# UNITED STATES PATENT AND TRADEMARK OFFICE

APPLICATION NO.	FILING DATE	FIRST NAMED INVENTOR	ATTORNEY DOCKET NO.	CONFIRMATION NO.
10/661,847	09/12/2003	Charles Edward Boardman	24-AT-135243	8534

## Office Action Summary

## **DETAILED ACTION**

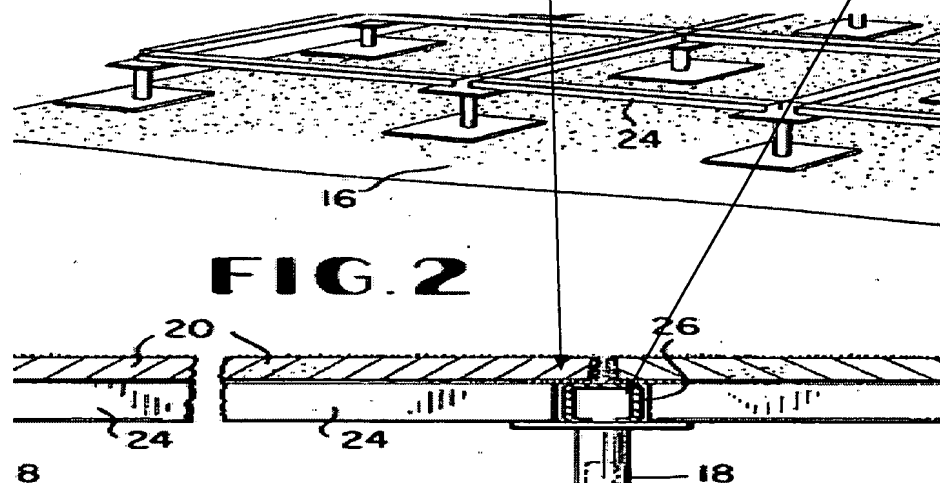
Anthony does not appear to expressly disclose;

that there is at least one groove in said bottom surface,

each said groove is sized to engage one of said support beams where a portion of said beam is positioned in said groove and

said removable support plate is in direct contact with said beam.

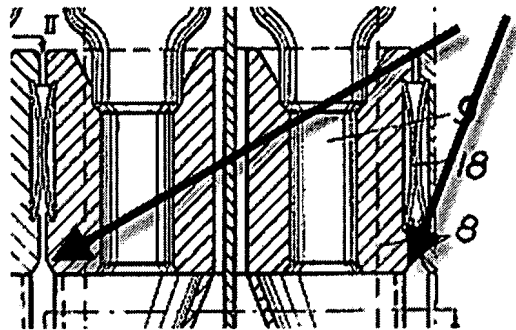
Further, Sodergard does indeed disclose a groove on the bottom as shown here
